Corrigendum No. 4 dated 06.03.2025 to IFB No. CQI8171P25 for ‘CQI8171P25 for EPCOM of 300 TPD of Segregated MSW based Compressed Biogas (CBG) Plant for Commercial use at Bhubaneswar, Odisha’

This Amendment to IFB No. CQI8171P25 is issued to notify the following:

DRAWING OF THE LANDMAP

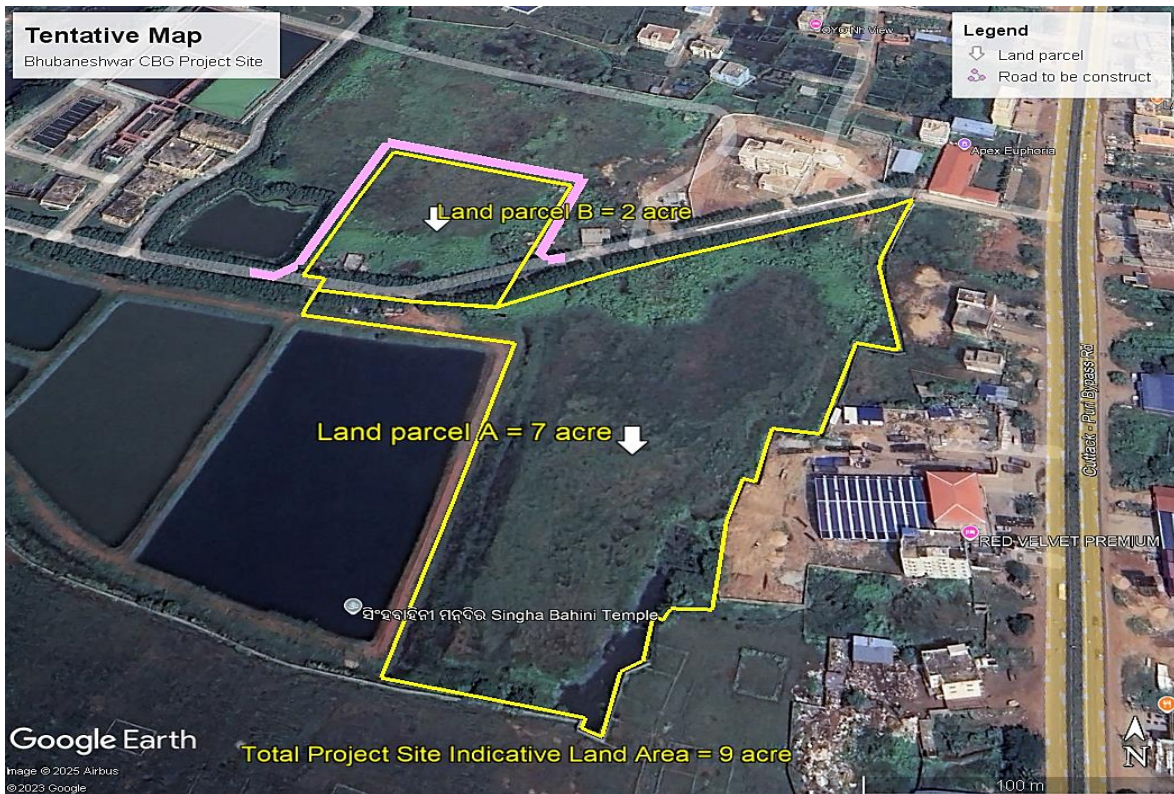
4.	Annexure-6 page 547	Annexure-6		Amended Annexure 6 with revised plot area is attached		
5.	Clause 8.2.9 (b)	Foundation		<p>In addition to Pile Design criteria given at clause no.8.2.9 (b) please take a note of the following while designing the foundation of heavy structure:</p> <p>1. Bidders are hereby notified that the design and execution of foundations must consider the findings and recommendations presented in the indicative Geotechnical Investigation Report provided as part of the tender documentation.</p> <p>2. As per the recommendations of the Geotechnical Investigation Report, pile foundations are essential for all heavy structures (like Digesters, Biological processing system Basins, Wet waste processing shed, Buffer tank, Fire water tank, Centrate sump, Digestate sump, Digestate Dewatering shed, ETP Shed, Sludge Dewatering feed tank, UF Tanks, Admin Building) within the CBG plant. The foundation system shall be designed to ensure structural stability and durability, with a minimum design service life of</p>

1. The road between the two plots is part of 2 Acres land patch and will be used for plant activity.
2. The Pink line shows the route for construction of diversion road having same dimensions and type of approximate length of 320 Meters in the scope of bidder. Cost should be included in the quoted price.
3. Bidder should visit the site to assess the land condition as the same is landfill site and also road route
